TOP CASE MODIFICATIONS

SIZE	DWG. NO.	REV
B	13766-4000-R7_TOP_CASE	B

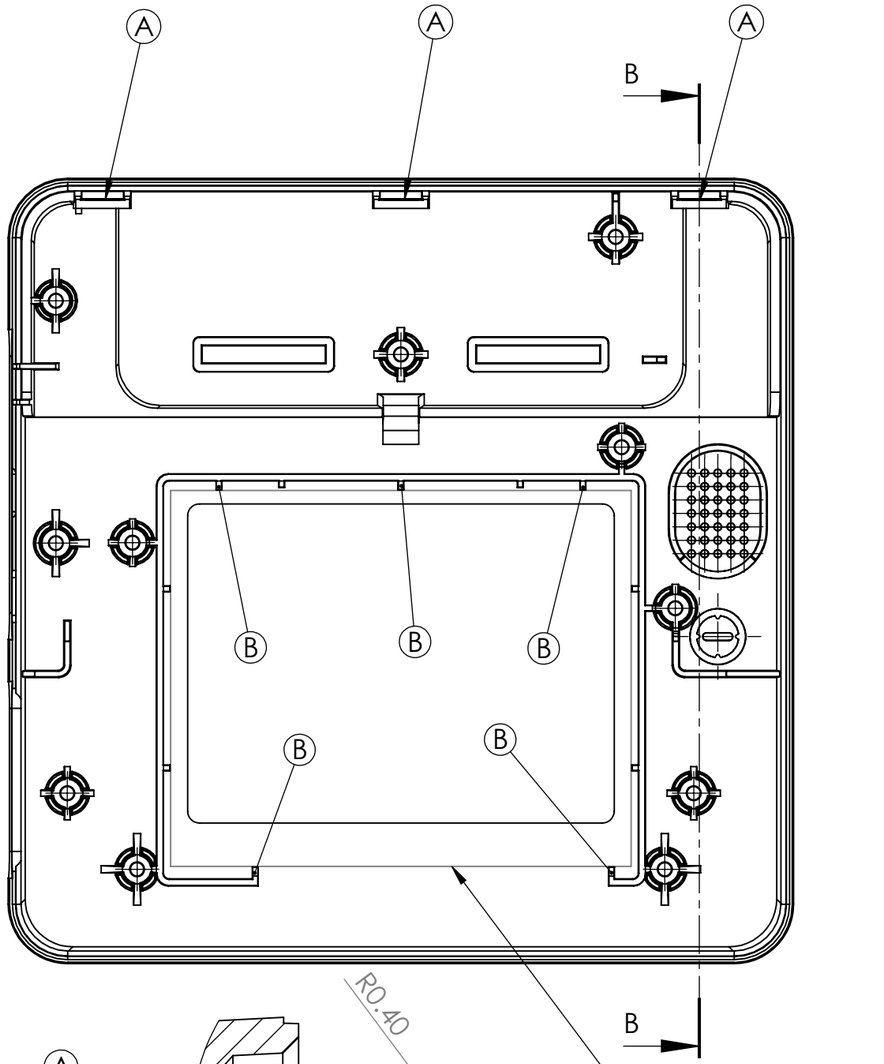
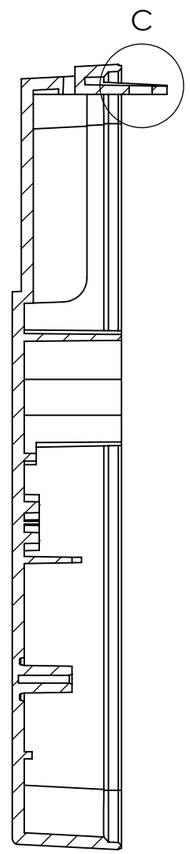
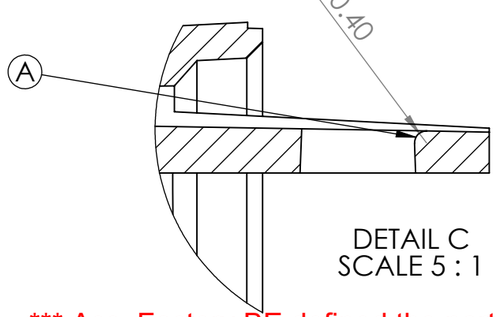
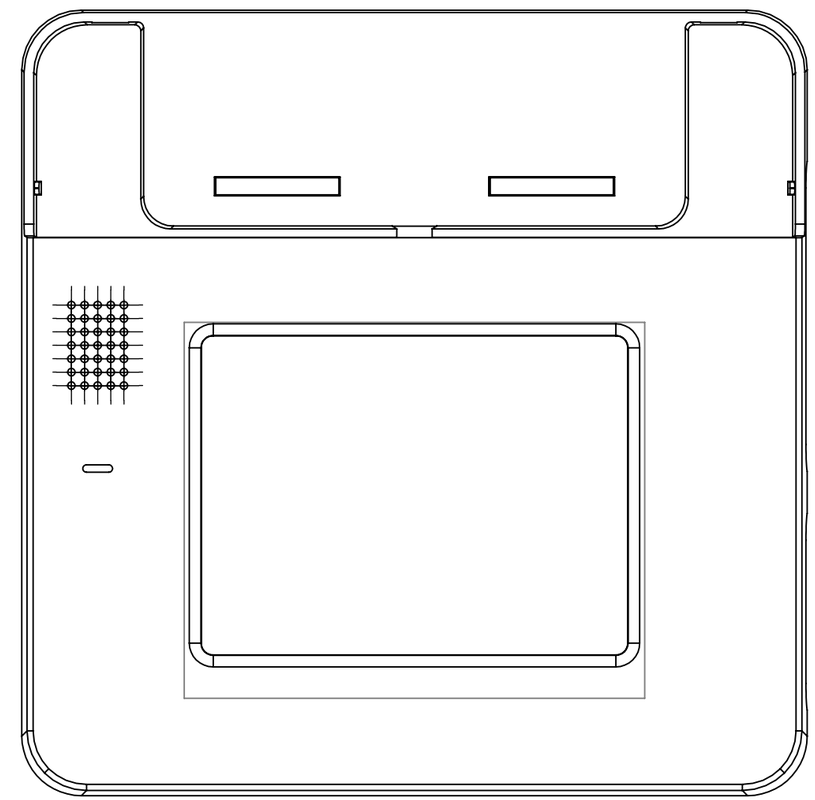
REVISIONS				
ZONE	REV.	DESCRIPTION	DATE	APPROVED
A4, B3, B4	A	ADD RADIUS TO OUTSIDE EDGE TO PREVENT BREAKAGE OF TABS	3/30/2015	
A3, A4	B	ADDITION OF LOCATING LCD LOCATING RIBS AND THE SHORTENING OF WALLS FOR DISPLAY CABLES	3/30/2015
